MSP BASE BUILDING – DESIGN NARRATIVE - WIDENED SOUTHERN ACCESS FOR MEWP

Author Jenny Ferguson

10.08.2021

DESIGN CHANGE NARRATIVE

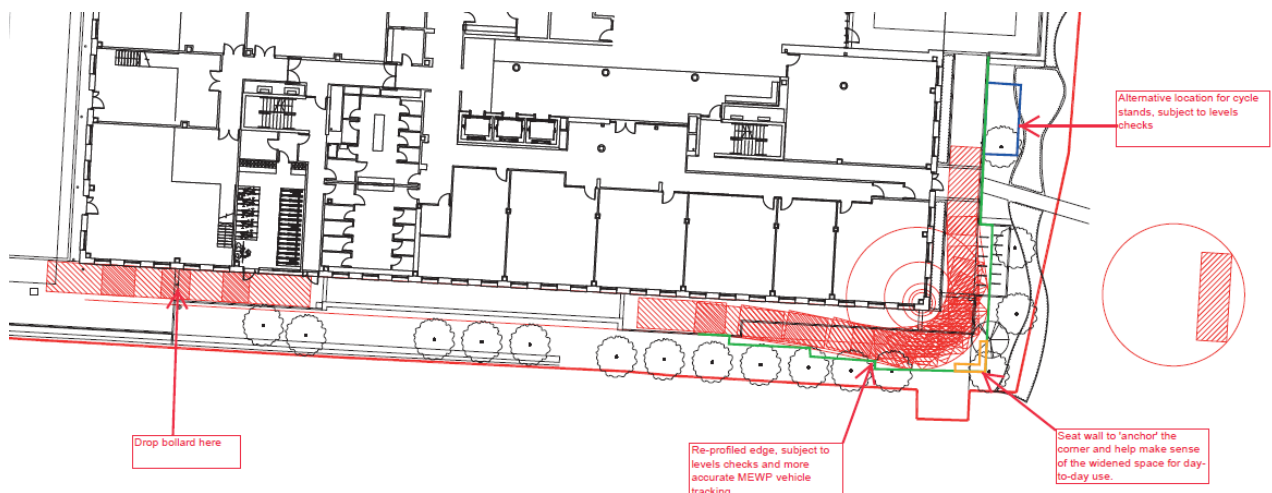
In order to accommodate the turning of the MEWP around the south eastern corner of the building, the southern boundary was required to be widened than originally proposed, so that the vehicle could manoeuvre around the corner of the building. 12 No. cycle stands were proposed to be repositioned approx. 9m further north of their previous location to the eastern side of the building. This can be seen in the feasibility image below, along with the vehicle tracking:

Extract below from drawing BA-BDP-01-XX-DR-L-(9-)L101_C01 :

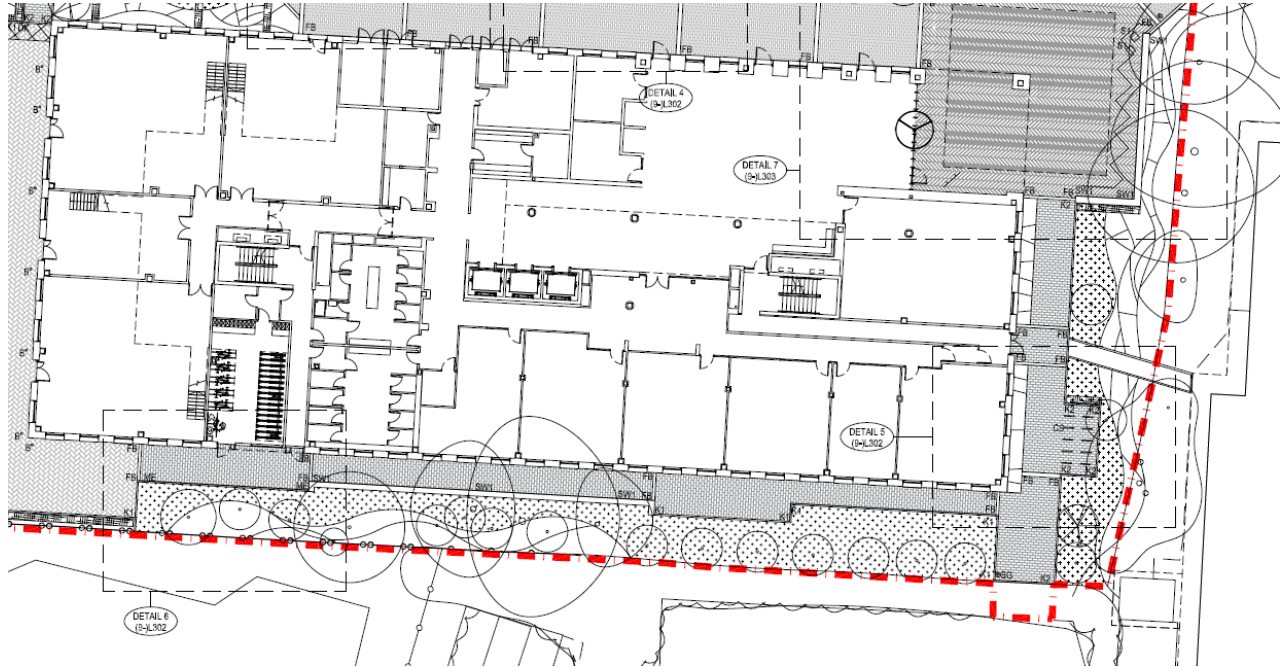
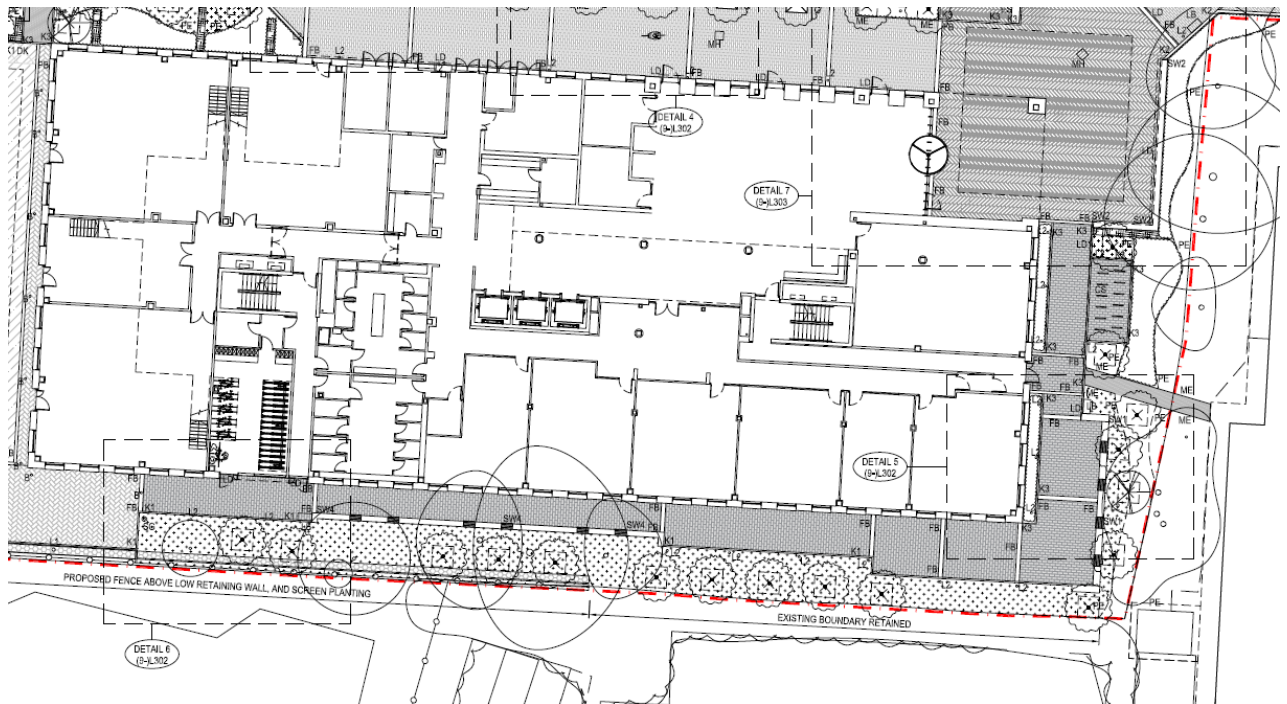
The plan below illustrates the previous layout issued for Planning, drawing BA-BDP-01-XX-DR-L-(9-)L101_C

The plan below illustrates the amended layout proposals, with the widened corner to accommodate the MEWP, and the repositioned cycle stands. A seat wall has been incorporated at the widened corner to improve the functional use of this widened space, and the future path extension previously shown connecting onto the southern boundary has been removed and replaced with soft landscape.
